Attachment 1
MV-2025-0010
10101 Old Shiloh Road
Page 1 of 1

INTERIOR ALTERATION /ADDITION ON EXISTING 2 STOREY SINGLE DETACHED RESIDENTIAL 10101 OLD SHILOH RD.

Attachment 3
MV-2025-0010
10101 Old Shiloh Road
Page 1 of 14

PROJECT TITLE:
INTERIOR ALTERATION/ADDITION ON
EXISTING SINGLE DETACHED
RESIDENTIAL

SITE PLAN
SCALE 1:750

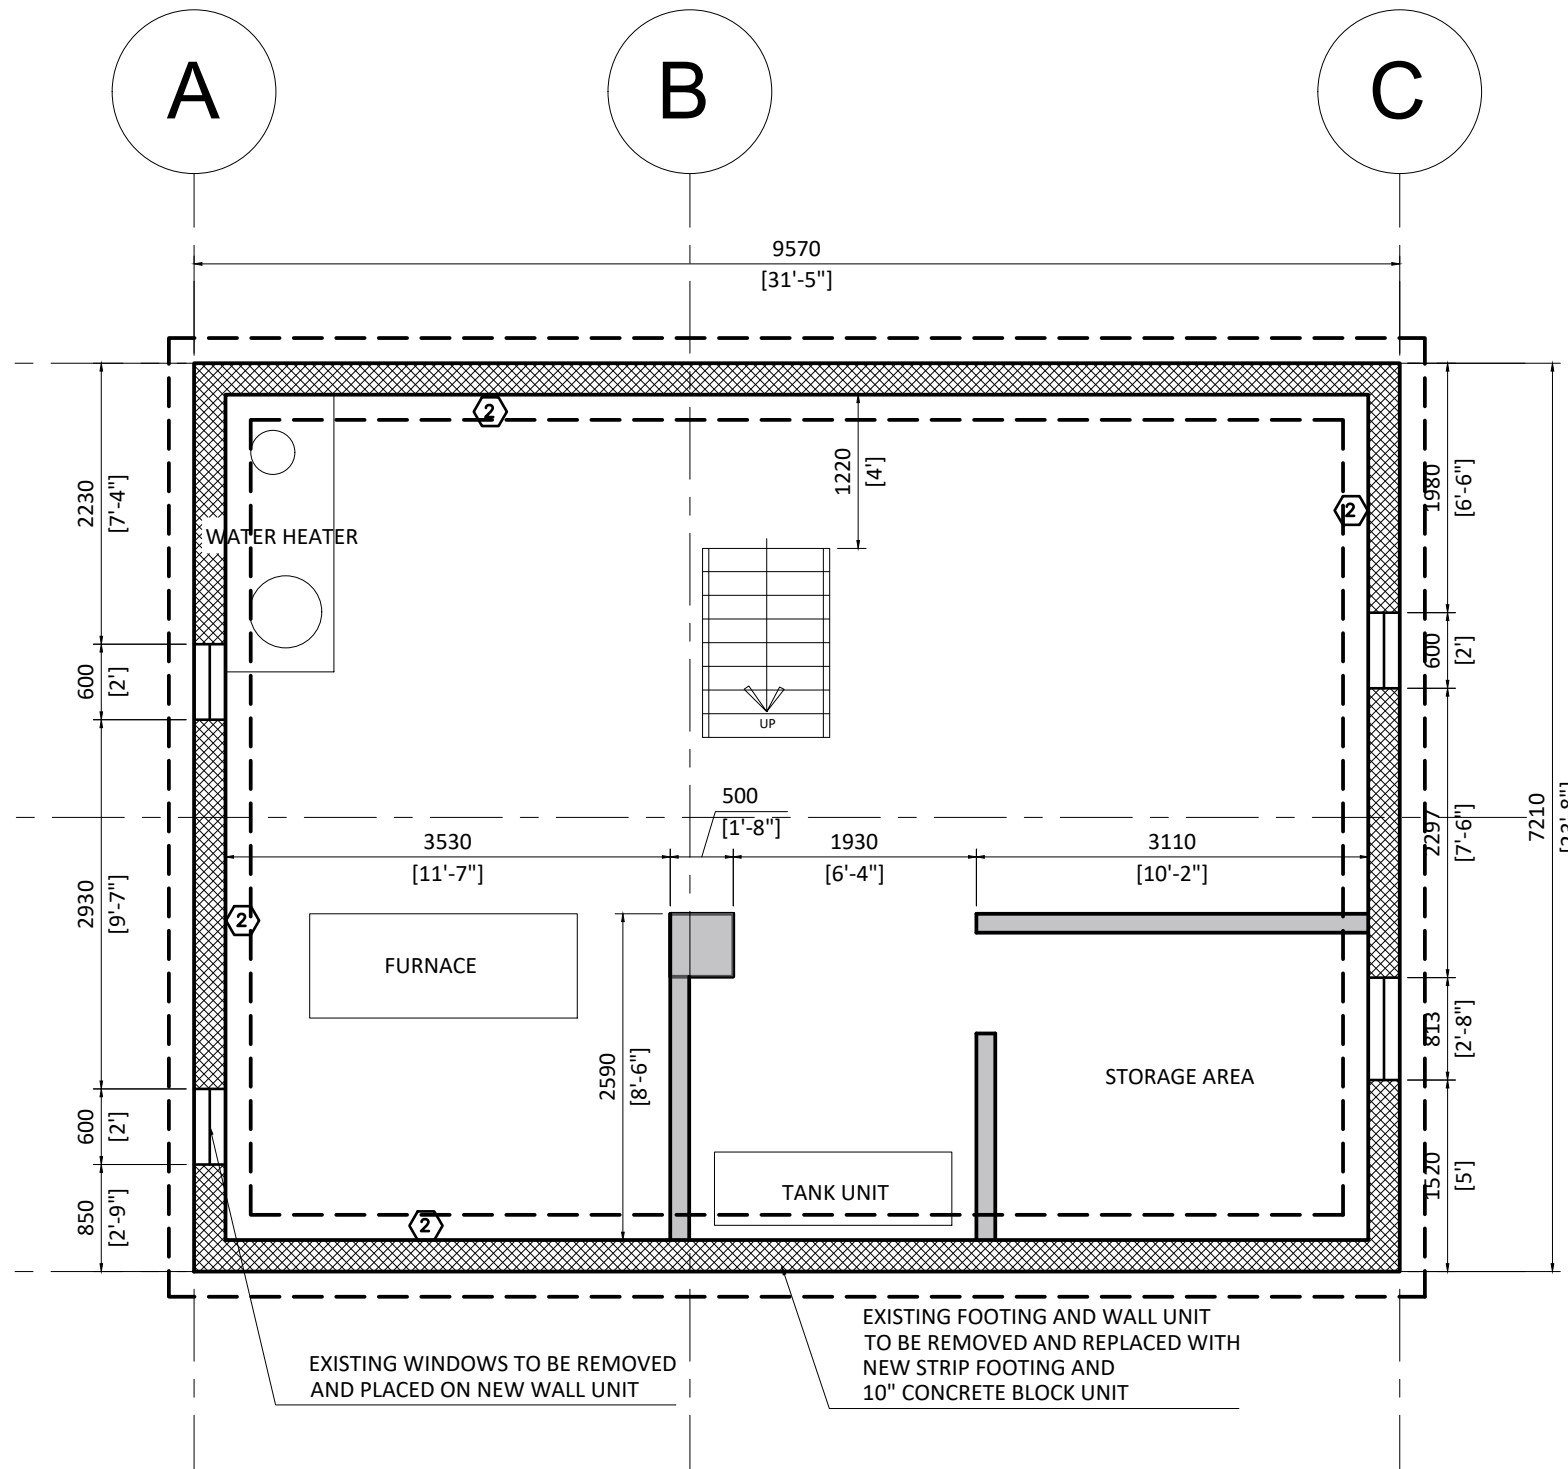
1. Lot Grading Plan: The applicant/owner shall provide a **detailed engineering drawing**, known as a Lot Grading Plan, that shows grade elevations of the entire lot, how surface water will be managed on a property to prevent flooding, erosion, and drainage issues, as well as existing and proposed entrance(s).
2. Check List: The applicant/owner shall provide a **completed drawing checklist**, which is to be signed by the designer of the drawing. The checklist template is linked [here](#).

Note: the Lot Grading Plan shall be prepared by a Professional Engineer or Ontario Land Surveyor skilled and competent in such works and all in accordance with the requirements of Part 4 of [By-law 2022-0038 \(REG-1\), as amended](#). Once these conditions are fulfilled, a **Site Alteration and Entrance Permit will also be required**. Related information can be found on the Town's website linked [here](#) and [here](#).
